Comment Date: May 2, 2011 14:17:41PM
Solar Energy Development PEIS
Comment ID: SolarD11812

Re: Endorsement of Cultural Resources Preservation Coalition Letter on Solar PEIS

Re: A NEPA EIS is no substitute for required FLPMA regulations

Figure 8. Delamar Valley SEZ

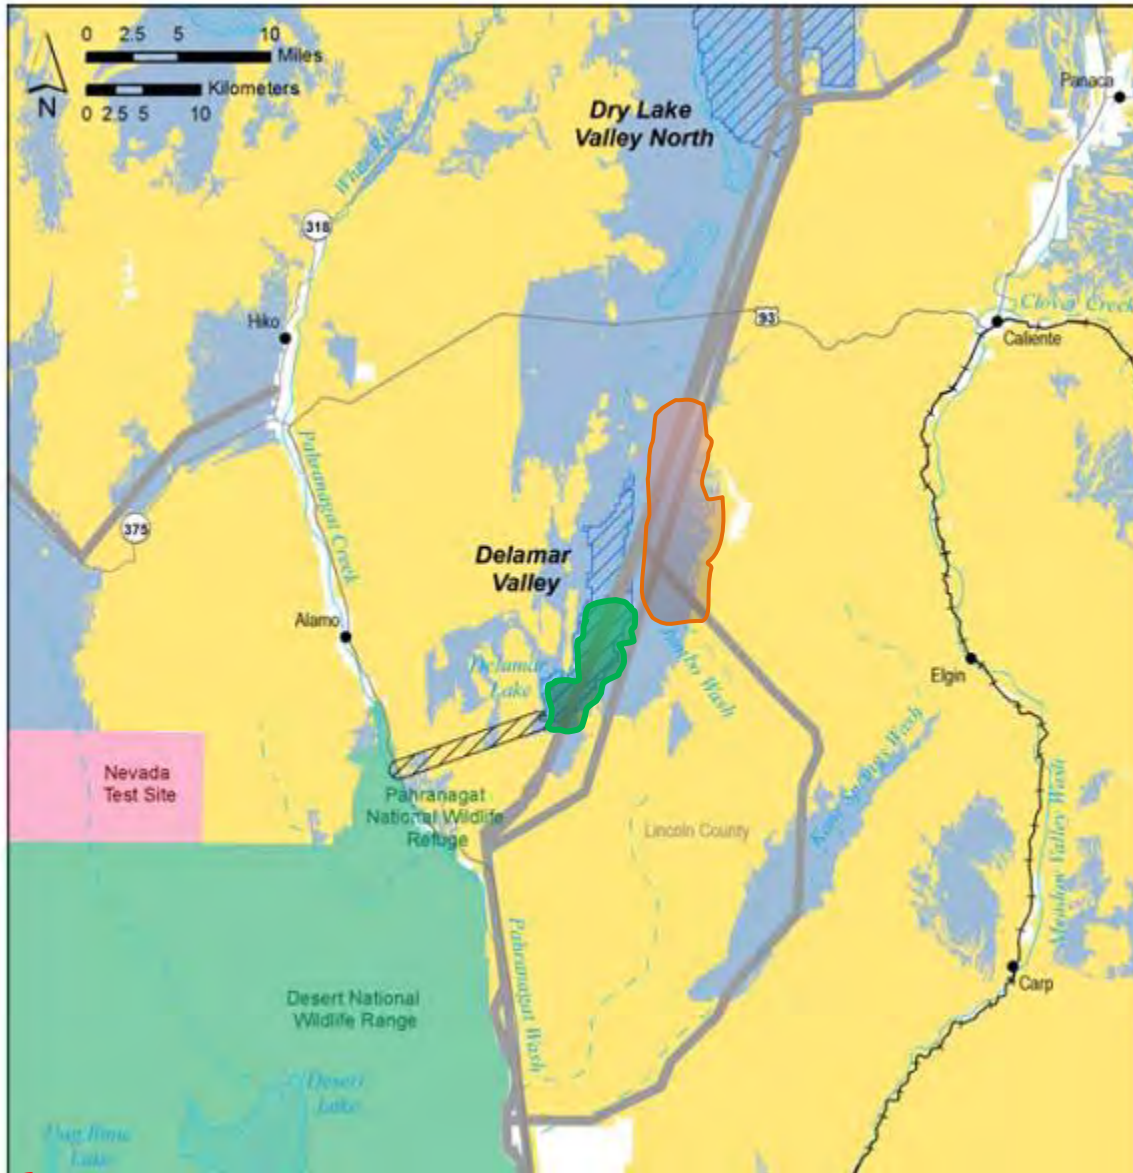
This SEZ is located outside of the Mojave Desert ecoregion, but is proximate to several ecoregionally important conservation sites such as Pahrangat Valley, the Hiko Wash, Warm Springs/Moapa/Muddy River, Ash Springs and Desert National Wildlife Refuge. The underground hydrology is too poorly understood to allow further drawdown of groundwater within a reasonable range from these desert wetland habitats, all of which contain endemic and federally listed species. The location is remote with no proximate significant end user of power generated there. The majority of this SEZ is apparently on intact landscapes, but of primary concern is the presence of Jumbo Wash through the center of it. Any facility approved within this SEZ should be sited north of Jumbo Wash away from the desert playa wetlands at the southern tip of the SEZ.

If renewable energy generation is needed and justified in this general area, the acreage containing the playa wetland at the southern tip of the SEZ should be removed from consideration. That acreage may be replaced to the northeast of the current configuration with little impact on local wildlife, and any technology approved in this SEZ should be as minimally consumptive of water resources as possible.

Figure 10. East Mormon Mountain SEZ

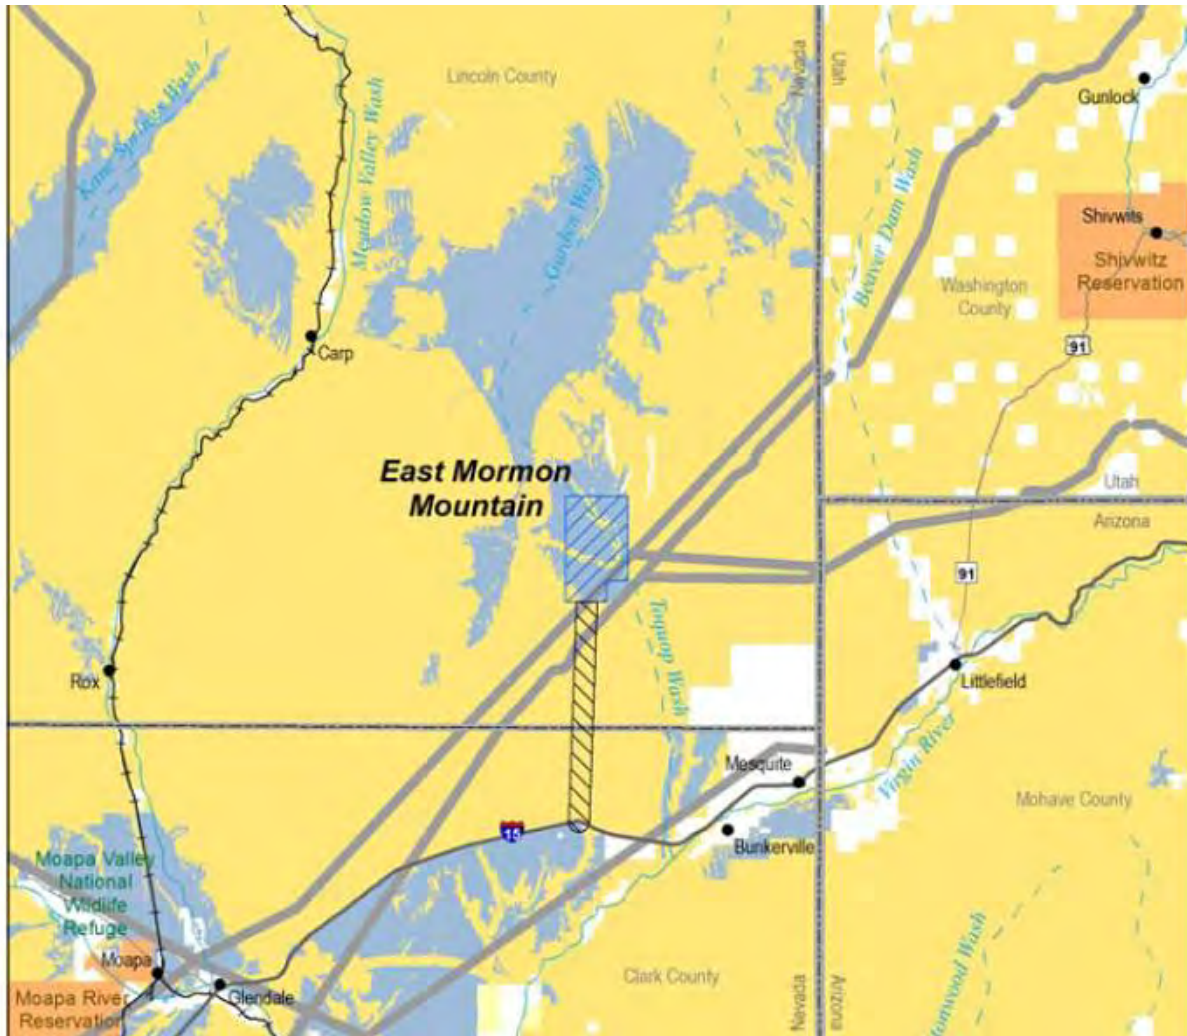
Toquop Wash should be avoided for the siting of any facility developed within this SEZ since it is a regionally important desert wash containing many of the Mojave Desert ecoregionally significant plant and animal species such as gila monster, desert tortoise, sidewinder, American badger, bobcat, southwestern burrowing owl, phainopepla, and catclaw acacia, among many others.

The location of a large renewable energy facility is unlikely to significantly compromise what has already become a major invasive weed breeding ground. Nevertheless, further fragmentation of an already poorly configured Desert Tortoise DWMA (Mormon Mesa), by means of transmission line corridors, should be avoided. The Toquop Wash should be avoided completely.

Figure 11. Gold Point SEZ

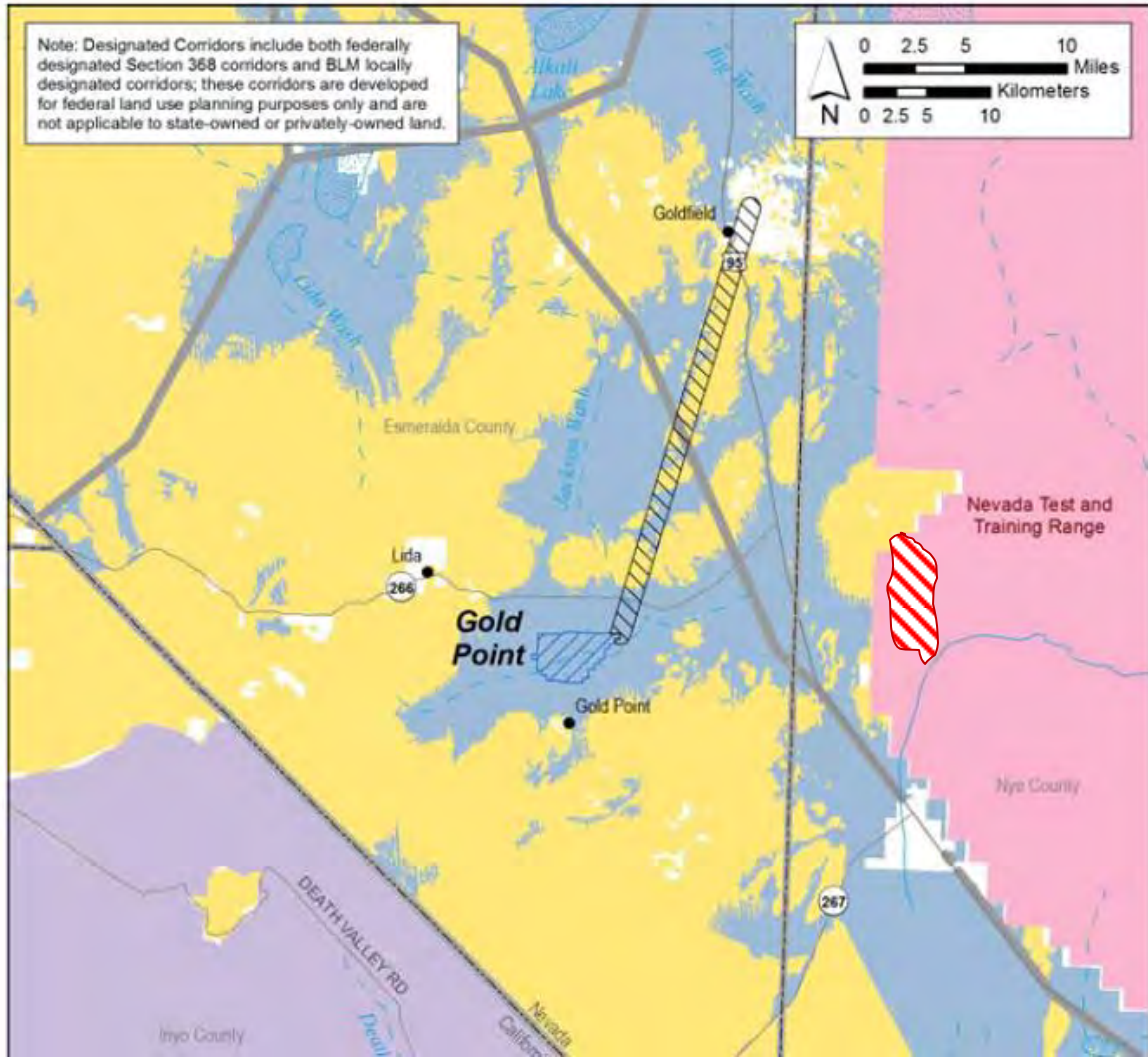
The general vicinity serves as habitat for several locally important species as identified in the PEIS such as Pronghorn antelope and Greater Sage Grouse. The proposed transmission corridor is particularly problematic for both of these species. Moving the SEZ location to the recommended zone would also alleviate these transmission corridor concerns since the new corridor could parallel US 95 without appreciable additional impacts to the species mentioned.

This SEZ is remote and not regionally significant as far as demonstrated power needs and furthermore is currently ecologically intact. It should be removed from consideration or relocated to the only nearby degraded or converted acreage at the intersection of US Highway 95 and State Road 264 as indicated on the map.
